Re: S/D 81-21 - Preliminary plat of Oak Cliff Estates 2nd Addition

Re: S/D 81-21 - Final plat of Oak Cliff Estates 2nd Addition

PROJECT NO. 32-81111-042
PROJECT: Oak Cliff Estates
2nd Addition
DATE: April 6, 1981

FROM: Dwaine Dunn
REFERENCE: Design Discussion in Your Offices
This Date

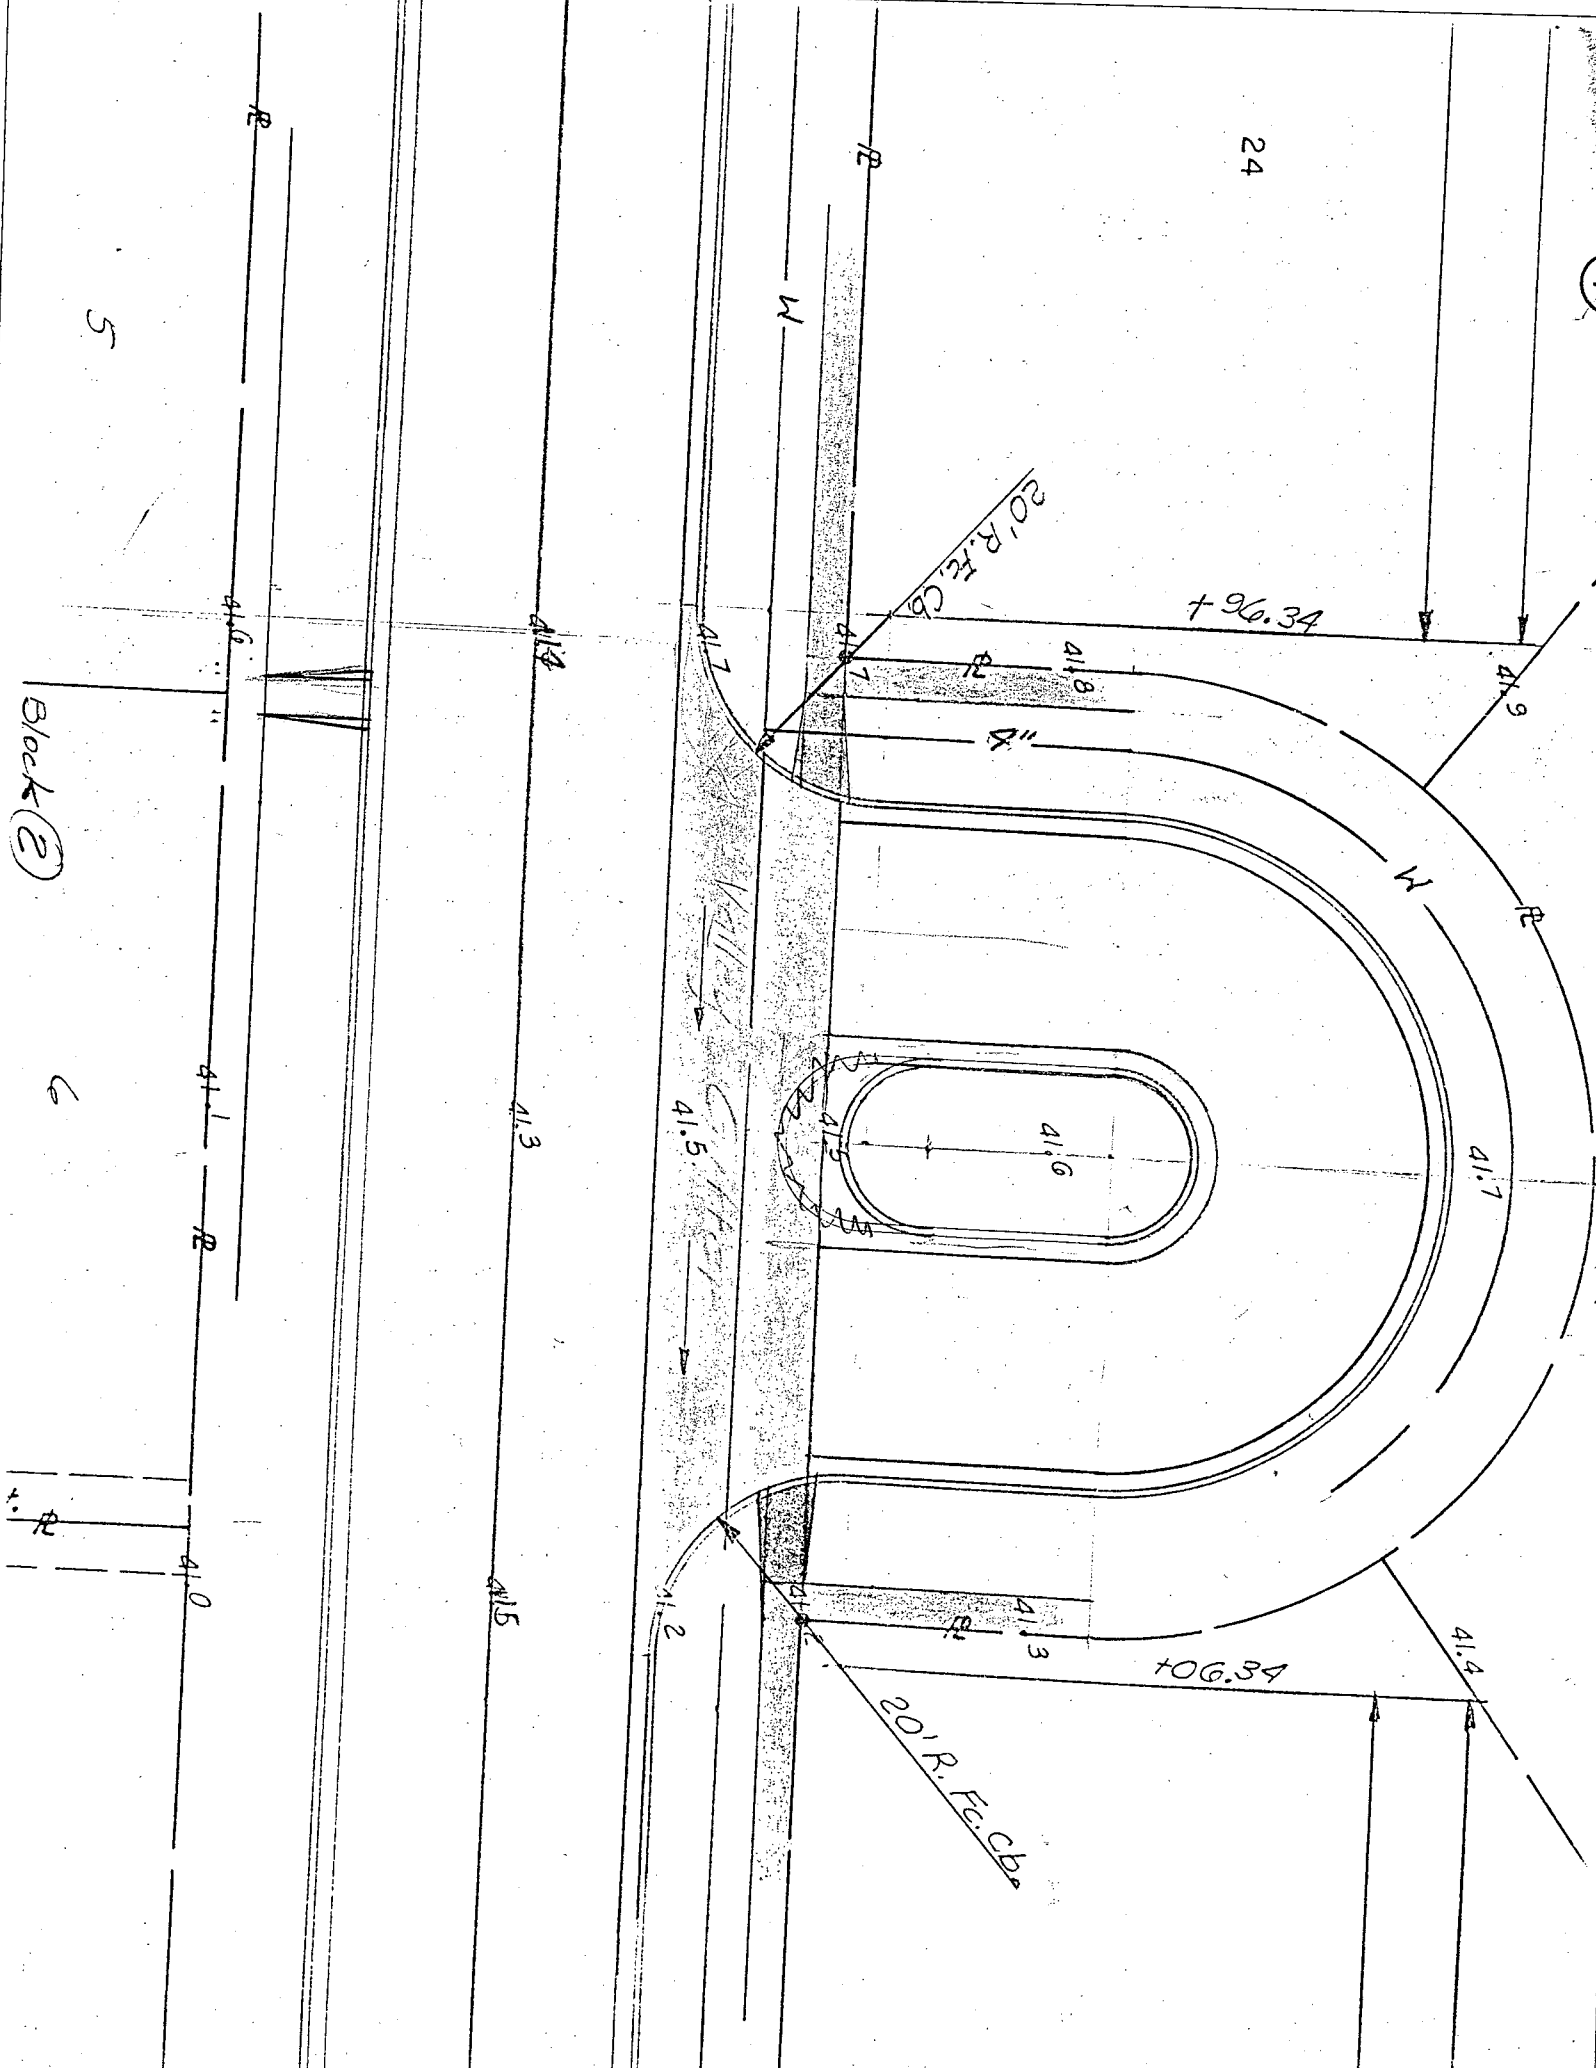
1. Texas Court median nose to be pulled north so that the median curb is out of the Valley Gutter and and 2-1/2 foot curb and gutter section is adjacent to the Valley Gutter as shown on the attached drawing.

The wheelchair ramps shall extend straight through east and west to keep them out of the flow in the Valley Gutter and one wheelchair ramp shall be installed opposite Texas Court centered on the property line between Lots 5 and 6, Block 2 extended, also shown on the attached drawing. All quantities of Texas Court shall be charged to property.

2. At the intersection of Lark and Texas the wheelchair ramps shall be installed in the middle of the return with the sidewalk on either side being depressed enough to maintain the required maximum slope of 1" per ft. Steve Lackey to make change in intersection now in final process toward construction to move curb depression to center of return.

3. At the intersection of Texas and Maize Road, in lieu of a cross road pipe under the Texas hookup, attempt to route the water from the north and the bypass from the inlet on Texas into the front of proposed inlet of north end of return on Maize Road. The existing and proposed Maize Road ditches are too shallow to accomodate a pipe and the new S.W.S. on Maize Road is too shallow to ditch across.
